inspection report

Permit No. ACT/015/009
Inspection Date 7/31/90

Permittee/Operator Name Beaver Creek Coal Co.
Business Address P.O. Box 1378
City Price State Utt Zip 84501
Mine Trail Mtn #9 ☐ Surface ☒ Underground ☐ Other
County Emery State
Company Official(s) Dan Guy
State Official(s) Bill Malencik, John Pappus / OSM - Rad Crull
Time of inspection 7:00 ☒ a.m. ☐ p.m. to 6:00 ☐ a.m. ☒ p.m. ☐ Partial ☒ Complete
Date of last inspection 7/12/90 Weather conditions Clear / Warm
Acreage 1415 ☒ Permitted 88 ☐ Disturbed ☐ Regraded ☐ Seeded 88 ☒ Bonded
Enforcement Action None - TDNs on permit or paperwork (3)
✓ (Followup Items For The Operator's Attention)

III. The Ditch Segement - lower Gate To & Into Sediment Pond (SKETCH).

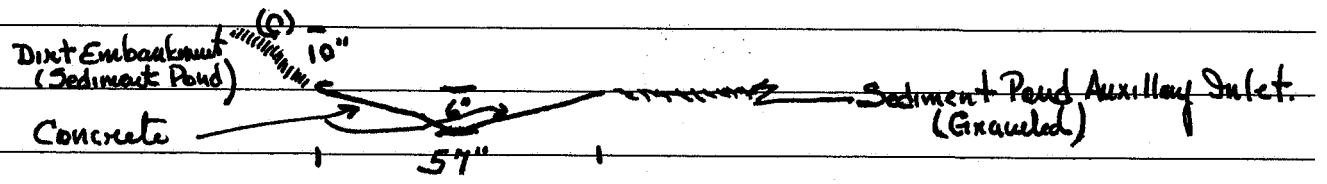
The conditions on the ground indicated that the ditch as currently existing is adequately handling the runoff. It is suggested that the operator as a preventative measure provide protection. This should be done on the dirt embankment noted as (C) above, discussed with the Division hydrologist before any on the ground work is performed.

Also, the current map should be updated to show the correct measurements and ditch shape. Also, it should be noted that the lower segement while still a V shaped ditch is different than the upper ditch. Also, the culvert symbol should be deleted on the undisturbed diversion near the portal. Diversion noted herein were the subject of a TON issued by the oversight inspector.
